Service Letter No. 150

July 10, 1950

SUBJECT: Bungee Cable PA-18 "105"

BUNGEE INSTALLATION
MODEL PA-18 "105"

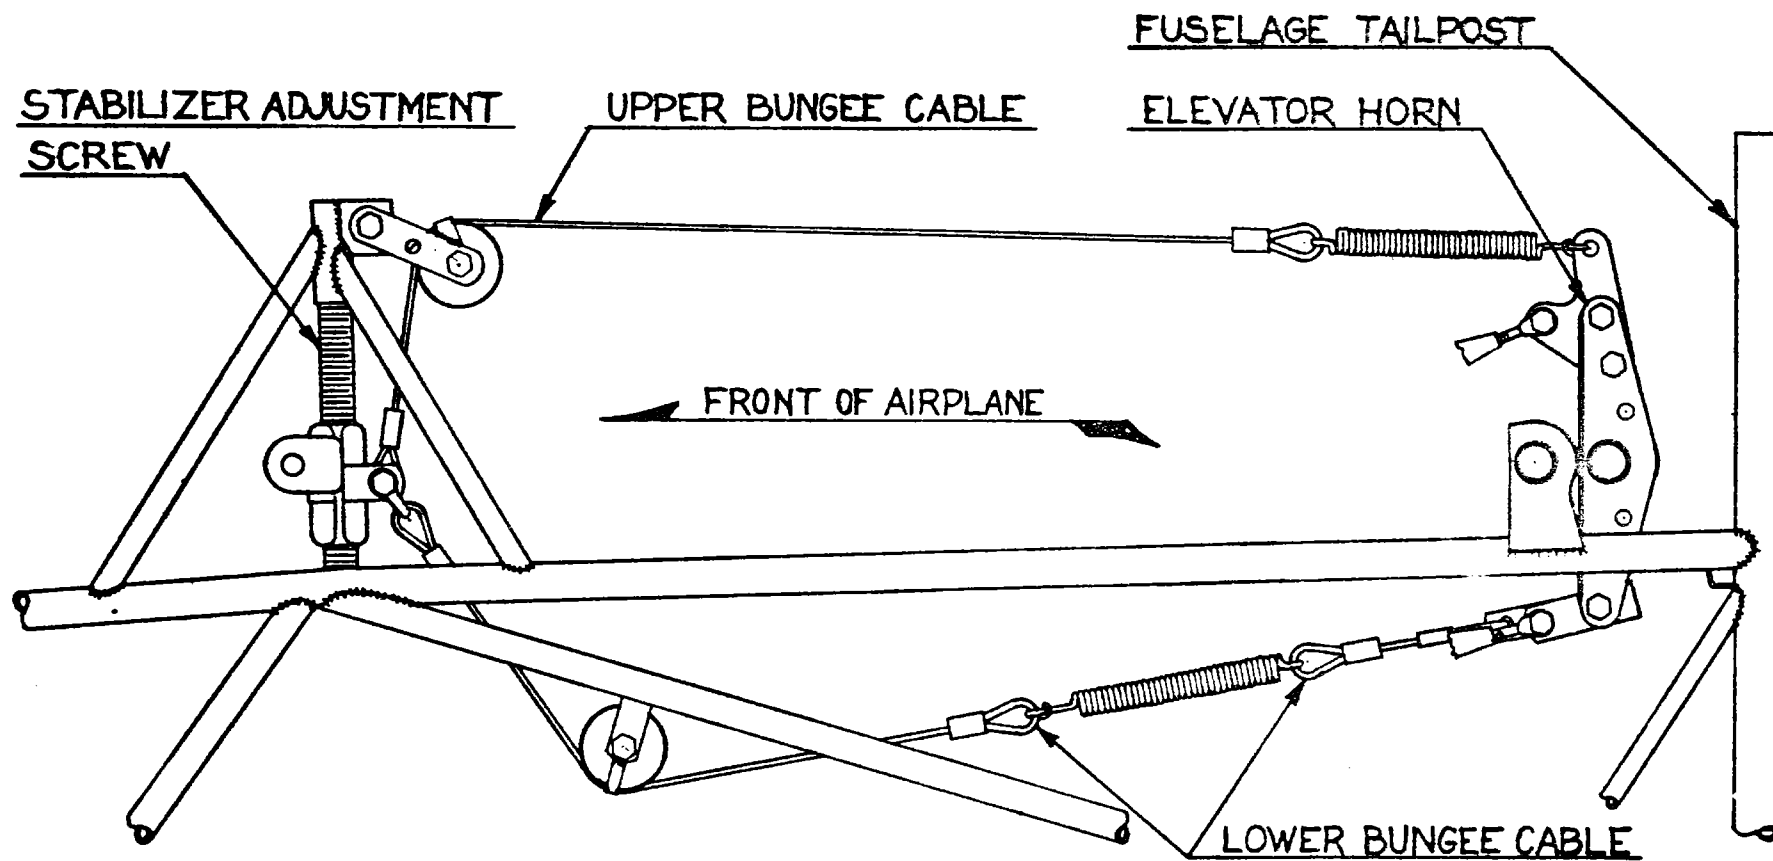
In view of the many comments which we have received from the field, relative to the extremely stiff elevator action on the PA-18 "105" our Engineering Department has issued approval to remove the lower bungee cable, as indicated in the sketch on the reverse side of this letter.

After removal of the lower bungee cable, the proper entry should be made in your log book.
